**TOWN OF MOUNTAIN VILLAGE  
REGULAR DESIGN REVIEW BOARD MEETING  
THURSDAY SEPTEMBER 6, 2018 10:00 AM  
2nd FLOOR CONFERENCE ROOM, MOUNTAIN VILLAGE TOWN HALL  
455 MOUNTAIN VILLAGE BLVD, MOUNTAIN VILLAGE, COLORADO  
AGENDA**

**TO:** Design Review Board  
**FROM:** Sam Starr, Planner  
**FOR:** Meeting of September 6, 2018  
**DATE:** August 30, 2018  
**RE:** Consideration of an Initial Architectural Site Review application for a new single-family dwelling on Lot AR-49, 116 Adams Way.

**TO:** Design Review Board  
**FROM:** Sam Starr, Planner  
**FOR:** Meeting of September 6, 2018  
**DATE:** August 31, 2018  
**RE:** Consideration of an Final Review application for a new single-family residence on Lot 165 Unit 11, Cortina Drive

**A1-3.1**  
ROOF PLAN

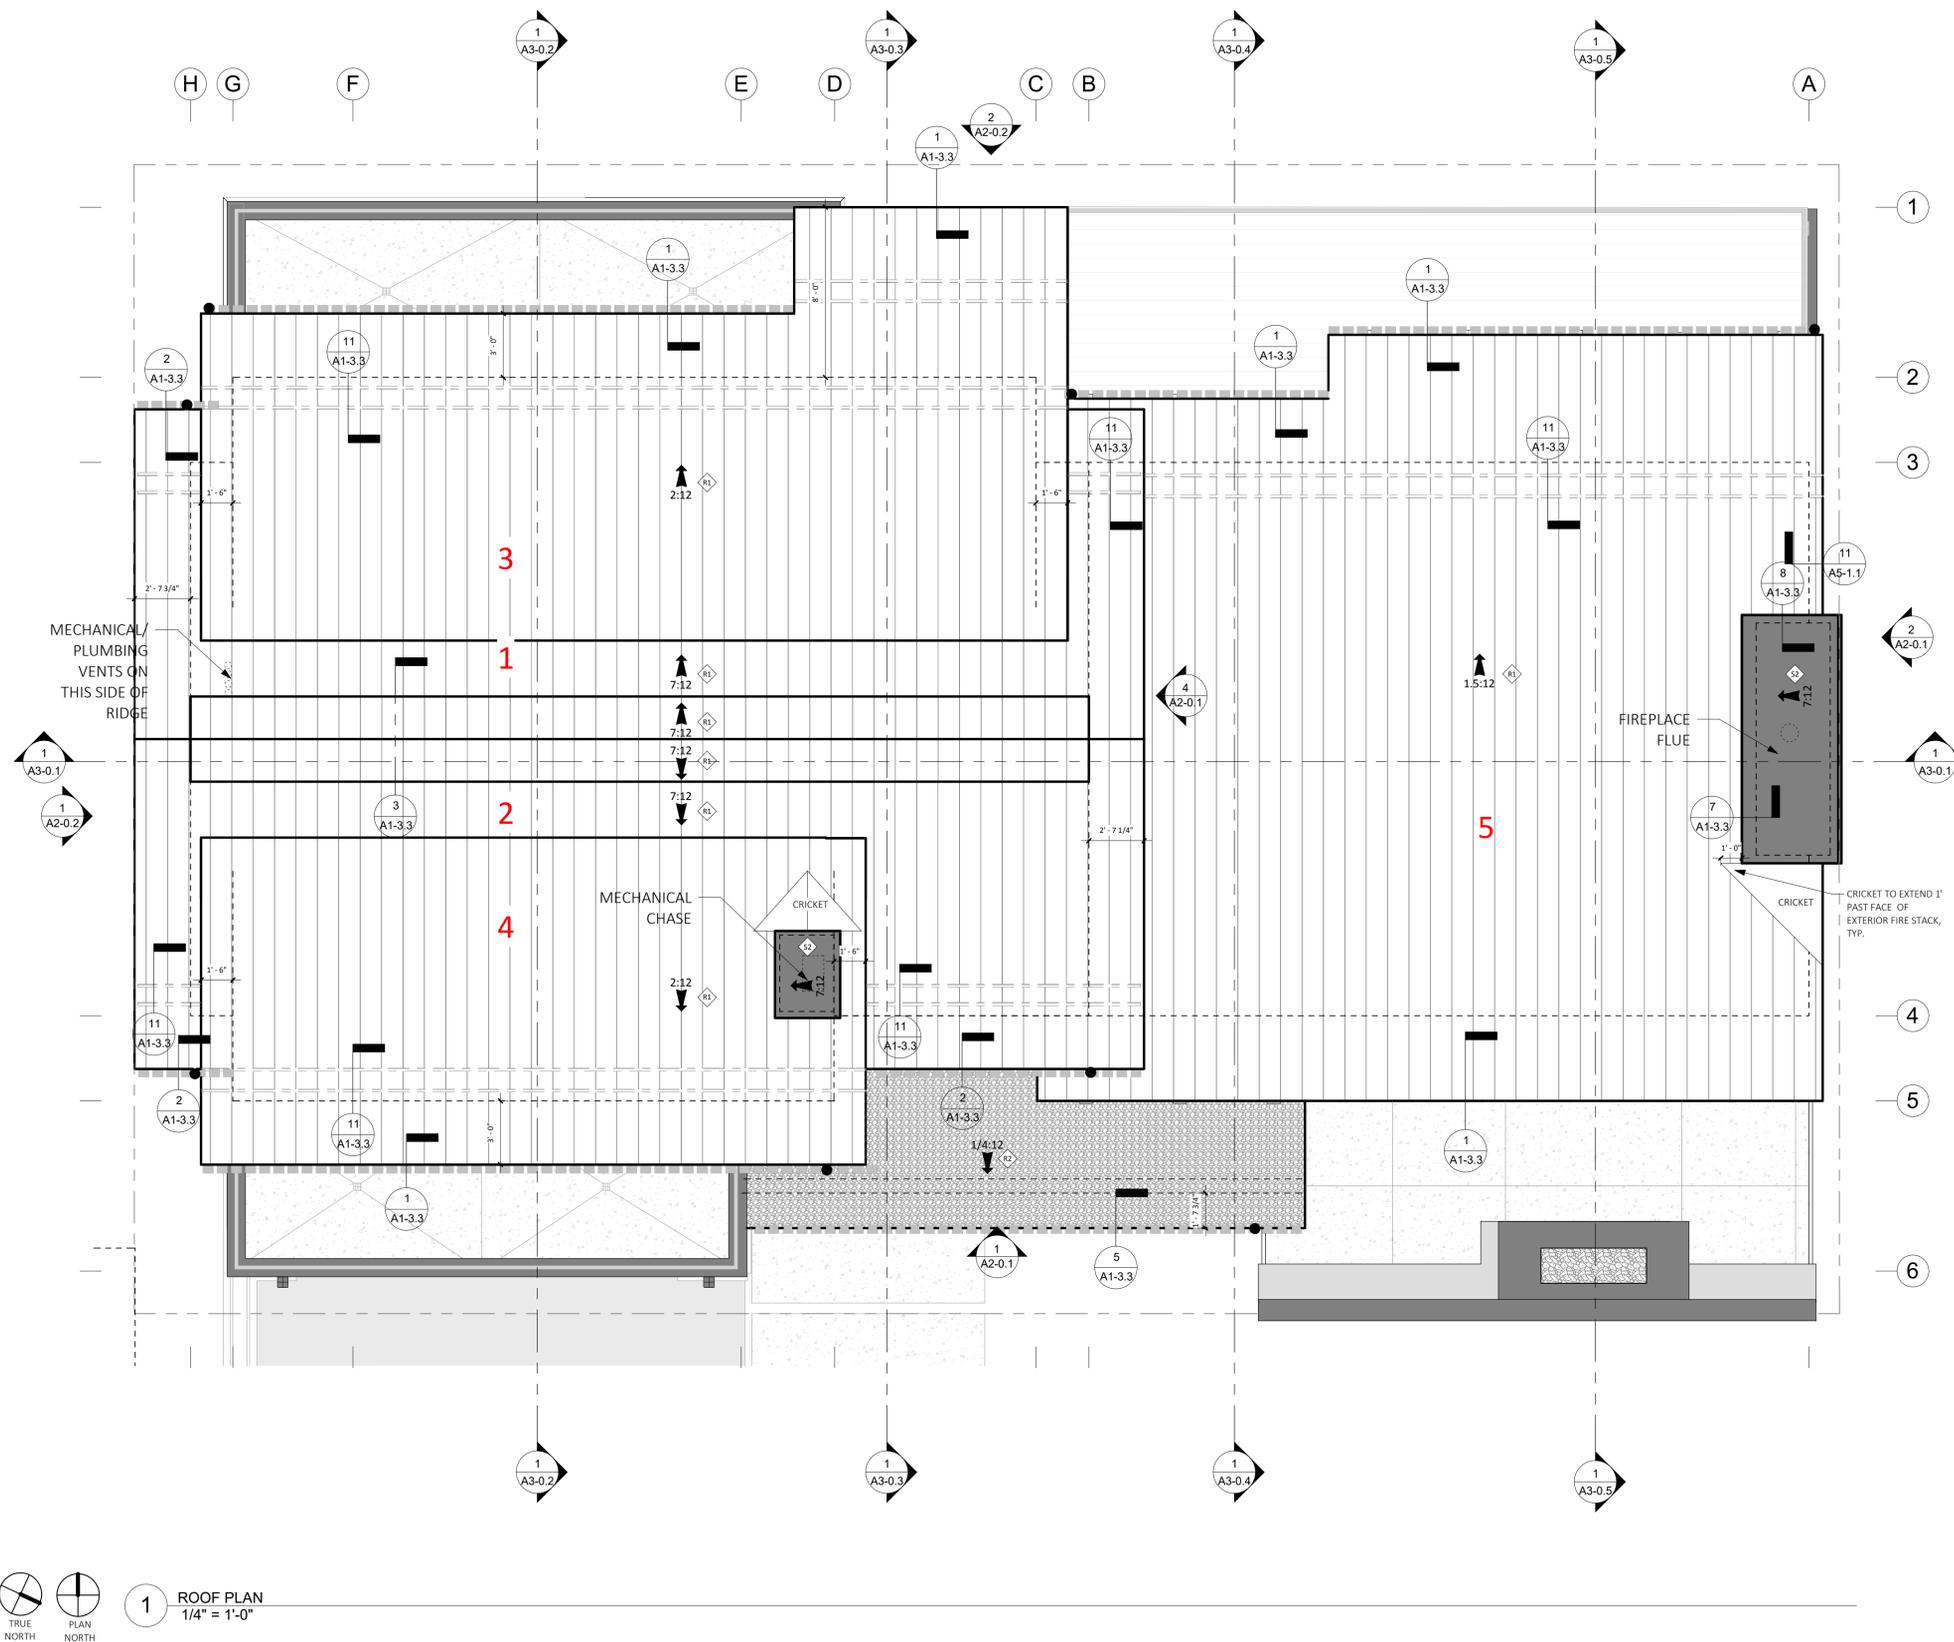
The CDC states that the roof shall be a composition of multiple forms that emphasize sloped planes, varied ridgelines, and vertical offsets. The primary roof forms for the proposed residence consist of 7:12 and 2:12 roofs, both of which are gabled.

for final review. In the revised plans attached as exhibit B, there are now 2 chimneys instead of 3, and both the slope and height of the chimneys have been reduced. The applicant still proposes to use a rusted standing seam for the roofing material.

E1-1.0  
LIGHTING PLANS

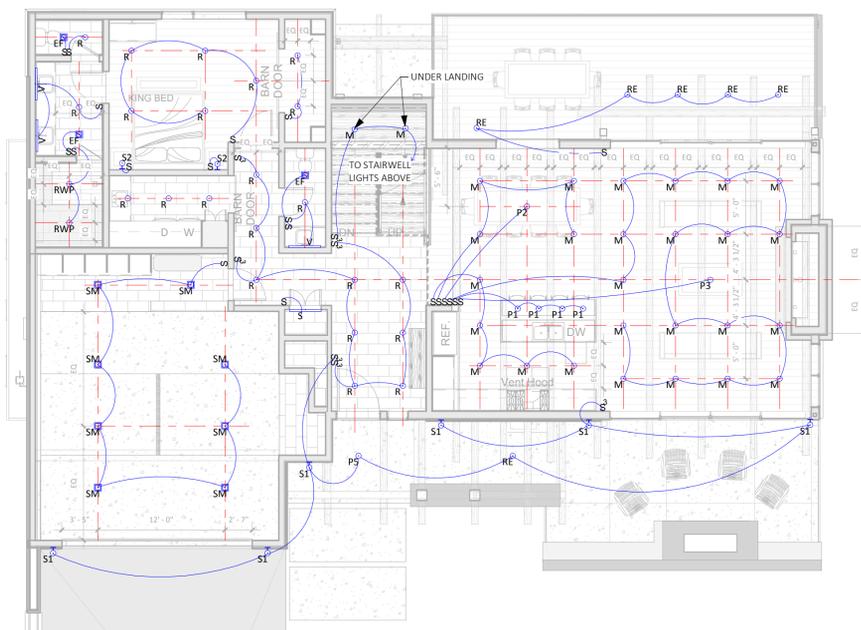
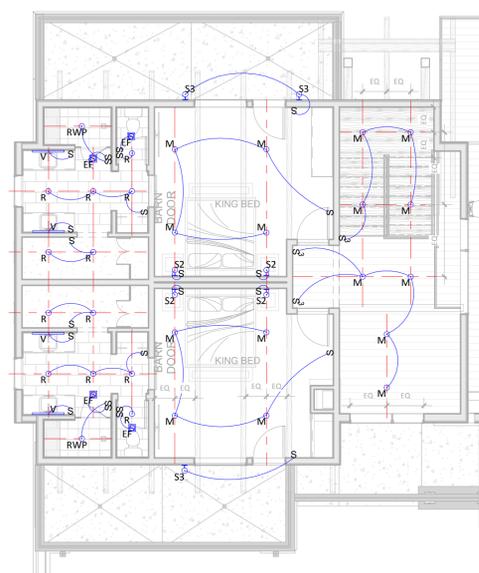
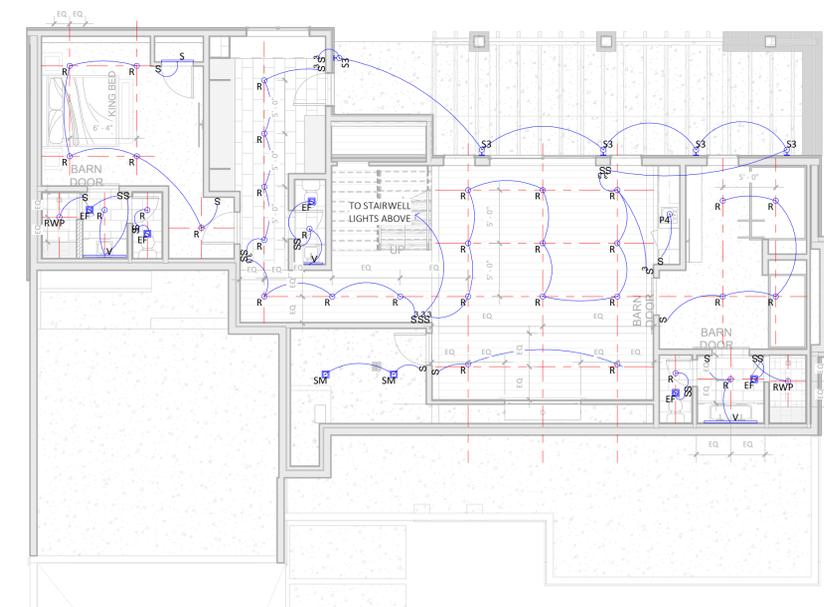
The placement of lighting is code compliant, and the locations include: decks, exterior egress areas, and the entryway. Owing to how small the lot and home are, planning staff still recommends that the exterior plan be revised and approved by staff/chair or chair's designate.

4. Applicant provide an updated Address Identification Sign demonstrating the presence of downlit, concealed LED light.
5. Exterior lighting plan be revised and approved by staff/chair or chair's designate.
